ADDENDUM No. 1

issue date August 30, 2024

PROPOSAL
WEST JEFFERSON COUNTY MUNICIPAL WATER DISTRICT
WATER DISTRIBUTION SYSTEM IMPROVEMENTS

ACE Job No. 123-01A

AIR & VACUUM RELEASE VALVE

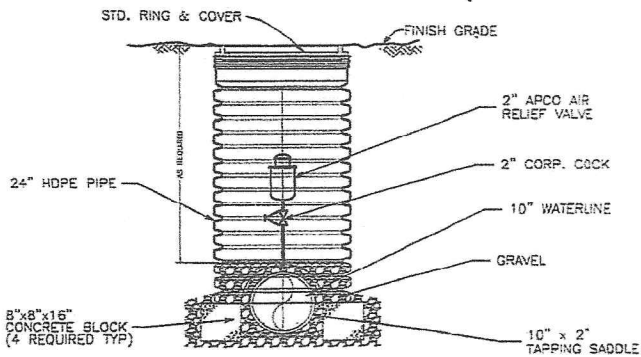
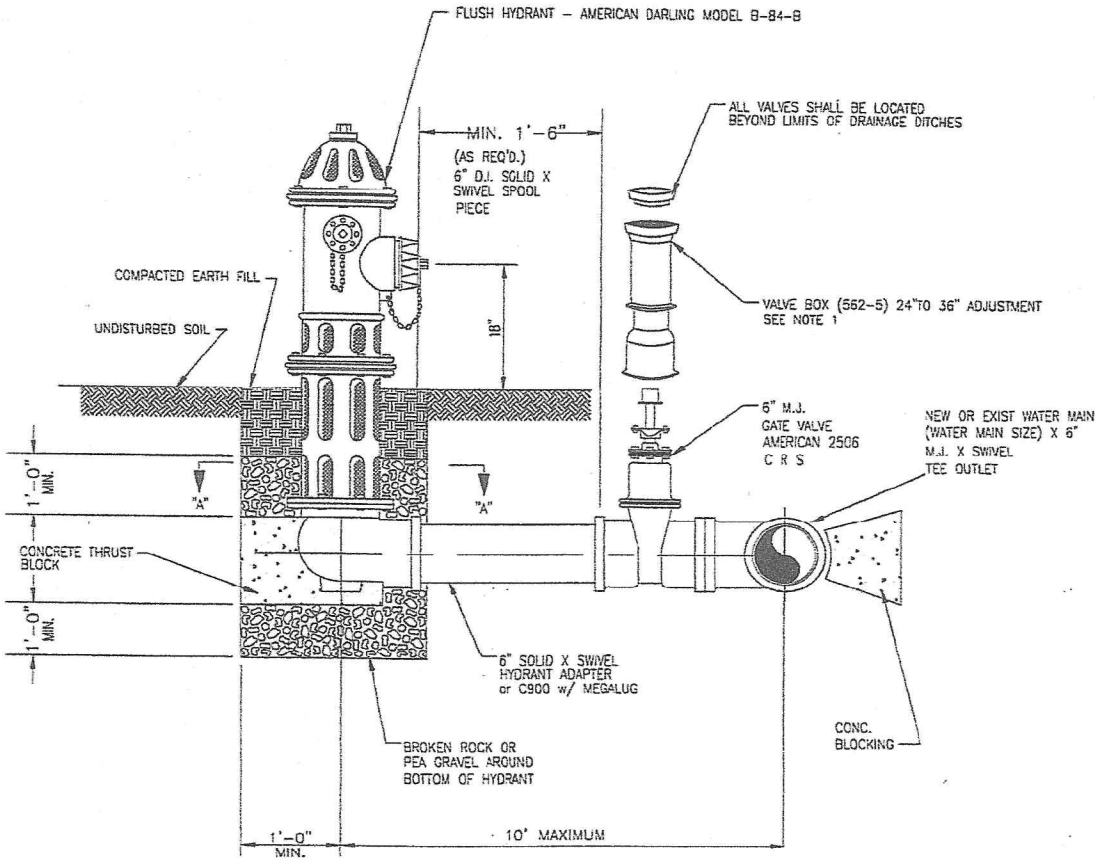
3. Provided for your use is a typical Air & Vacuum release valve assembly referencing an APCO air release valve product housed in a 24-inch HDPE pipe with a standard ring and cover at grade; also, a typical flushing valve unit assembly, all items of which should be included in the unit price bid for said item.
